**Minutes of Meeting**  
**WG: C37.010 - Circuit breaker application Guide**  
**Chair: Helmut Heiermeier**  
**Location: Galveston**

**29. April. 2013**

## CB application guide C 37.010

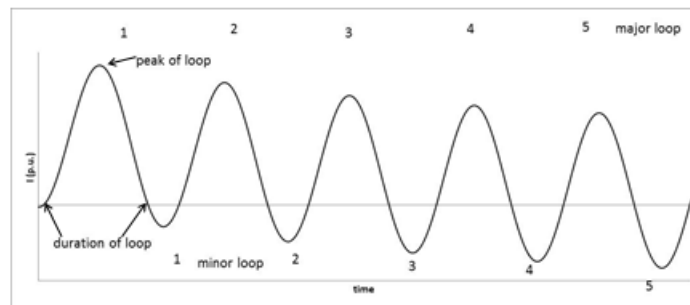
- Subclause 5.10.2 Asymmetrical requirements
- Several comments
- Figures 4-7 need improvement with regard to understandability
- A graphical representation of the asymmetrical current waveshape seems to be necessary
- A better description how to recalculate the tested values to the required values seems to be necessary
